# Technical Bulletin

## Installation: Greenstar Utility 2022+ 32/50 & 50/70 burner head settings

MISSING INFORMATION FROM THE INSTALLATION MANUALS:

Fig. 45 RDB 3.2 BX combustion head adjustment

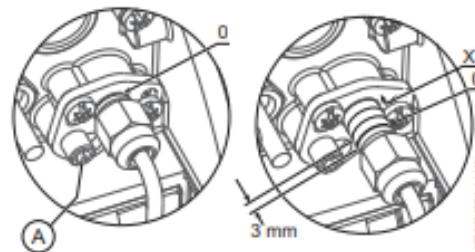
Fig 45 & 46 are missing from Pg 33.

These diagrams show where the adjustment marks are sited on each respective burner type and must be referred to as the method of adjustment is different to that on the smaller 12 – 32kW range of appliances.

- ▶ Turn the adjustment screw [A] and set the combustion head to the correct output required, refer to table 13.
  - Distance between two notches equals three millimetres
  - e.g. to set 21mm at the combustion head turn the adjustment screw [A] until seven notches are visible from the zero notch
  - e.g. to set 17mm at the combustion head turn the adjustment screw until six notches are visible from the zero [0] notch and then back the adjustment screw off one turn (1mm) to achieve 17mm.
  - One complete rotation of the adjustment screw [A] equals one millimetre of movement at the combustion head
  - All distances are measured from the zero [0] notch to the adjustment assembly face [X]
